# UNITED STATES PATENT AND TRADEMARK OFFICE

APPLICATION NO.	FILING DATE	FIRST NAMED INVENTOR	ATTORNEY DOCKET NO.	CONFIRMATION NO.
10/810,709	03/29/2004	Hirofaka Fukushima	ED-US020437	9049
22919	7590	06/30/2005	EXAMINER	
SHINJYU GLOBAL IP COUNSELORS, LLP 1233 20TH STREET, NW, SUITE 700 WASHINGTON, DC 20036-2680			RODRIGUEZ, SAUL	
			ART UNIT	PAPER NUMBER

## Office Action Summary

## **DETAILED ACTION**

Fig. 10

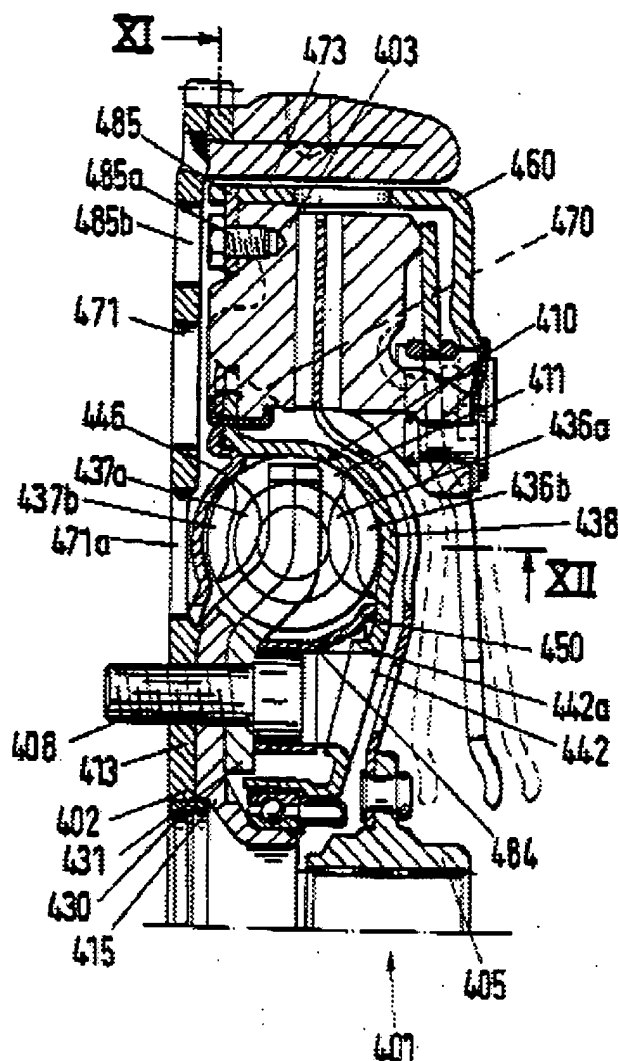
Claims 1-10, 19-29 and 39 as understood, are rejected under 35 U.S.C. 102(b) as being anticipated by Reik et al. ('245).

Reik et al. teaches a moveable flywheel assembly (Fig. 8, 10) comprising a flywheel (303, 403), a dual stage damper mechanism (310, 410) with springs disposed in an annular area, attachable and detachable flexible support member and/or torque transmission members (415, 431), an annular portion, a plurality of axial and radially extending portions (including thickness) nesting the damper mechanism, an axial gap, a main body with a friction surface, a friction generating arrangement with plates (381).

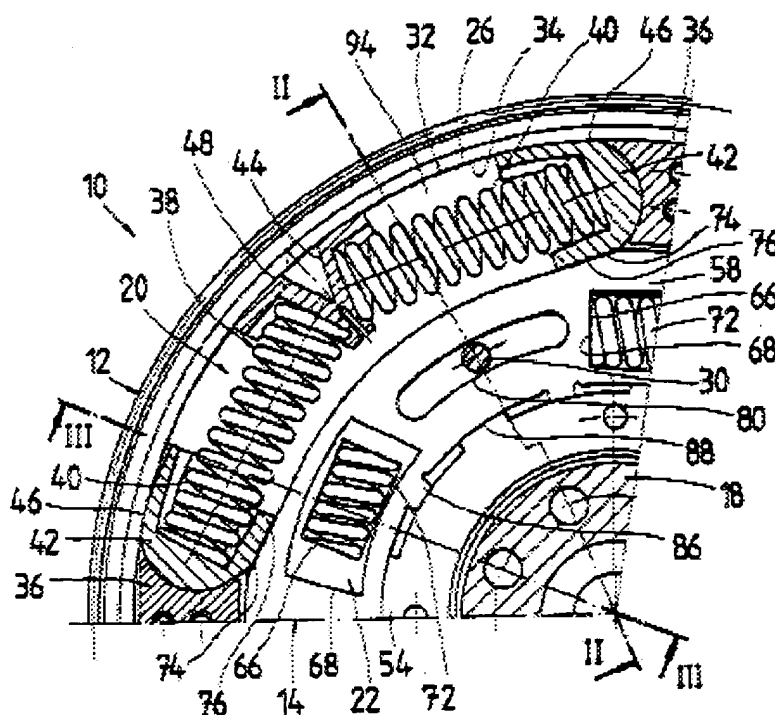
Claims 11-12, 15-18, 30-32, and 35-37, as understood, are rejected under 35 U.S.C. 103(a) as being unpatentable over Reik et al. ('245) in view of Feldhaus et al. ('804).

Reik et al. does not show members for supporting the springs. It is well know however to provide support members at the rotation direction ends of damper springs spring. For example, Feldhaus et al. discloses support members (36, 42, 44) with holes at the rotation ends of damper springs disposed on a flywheel assembly for torque transmission from a crankshaft of an engine (Fig. 2). Then, it would have been obvious to a person of ordinary skill in the art at the time the invention was made to add support members at the rotation ends of the springs of Reik et al. in view of Feldhaus to reduce the wear of the springs.
